# Access Compliance Report

## Public Rights-of-Way

### (Curb Ramps)

Intersection ID: 14724	Main Street: ALBEMARLE_RD	Cross Street: GUICE_CROSSING_LN	Location: NE
ADA ID: 2E4BB4A39F52	Ramp Type: Perp	Initial Pass/Fail: Fail	Overall Compliance: No
Severity Score: 23.75			
Codes/Mitigation Info/Possible Solution		Field Measurements/Component Compliance

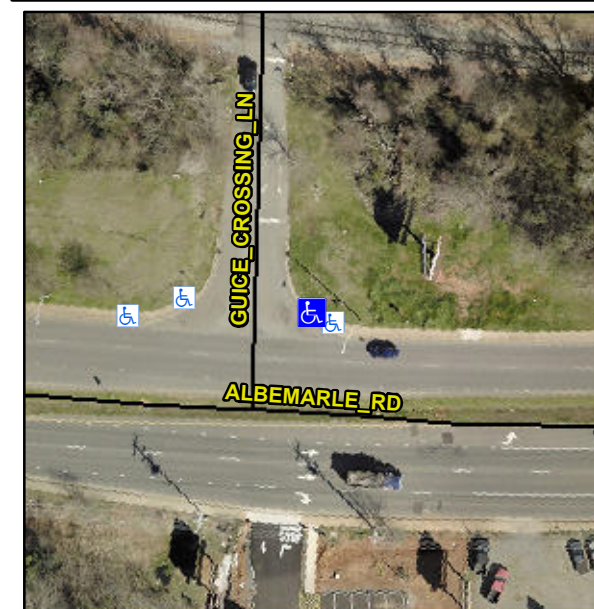
**Not Found, R304.5.1, R302.7**

Compliance	Description	Data	Compliance	Description	Data
N/A	Ramp Length (in)	60.0	Yes	Ramp Slope (%)	7.2
No	Ramp Width (in)	43.0	Yes	Ramp XSlope (%)	1.1
N/A	Flare Type LT	N/A	N/A	Flare Type RT	N/A
N/A	Flare Slope LT (%)	N/A	N/A	Flare Slope RT (%)	N/A
N/A	Flare Traversable LT?	N/A	N/A	Flare Traversable RT?	N/A
N/A	Landing Length (in)	N/A	N/A	DWS Provided?	N/A
N/A	Landing Width (in)	N/A	N/A	DWS Contrast?	N/A
N/A	Landing Slope (%)	N/A	N/A	DWS Length (in)	N/A
N/A	Landing X Slope (%)	N/A	N/A	DWS Full Width?	N/A
N/A	Landing Curb? (Y/N)	N/A	N/A	DWS Offset (in)	N/A
N/A	Shared Landing?	N/A			
N/A	Gutter Ponding?	N/A	N/A	Gutter Slope (%)	N/A
N/A	Gutter Lip Ht (in)	N/A	N/A	Gutter X Slope (%)	N/A
N/A	Painted X Walk1?	No	N/A	Painted X Walk2?	N/A
	X Walk 1 Direction	To W		X Walk 2 Direction	N/A
N/A	X Walk 1 Width (in)	N/A	N/A	X Walk 2 Width (in)	N/A
	X Walk 1 Slope (%)	0.7		X Walk 2 Slope (%)	N/A
	X Walk 1 X Slope (%)	0.2		X Walk 2 X Slope (%)	N/A

N/A	Ramp inside XWalk1?	N/A	N/A	Ramp inside XWalk2?	N/A
	Road Slope (%)	N/A	N/A	Clear Space?	N/A
	Road X Slope (%)	N/A	N/A	Clear Space to XWalk (in)	N/A
N/A	Any Obstructions?	N/A	N/A	Storm Grate/Utility Hazard?	N/A
	Obstruction Type			Storm Grate/Utility Type	
		N/A			N/A
		No		Surface Condition? (G/P)	Poor

**Remove & Replace Entire Ramp.**
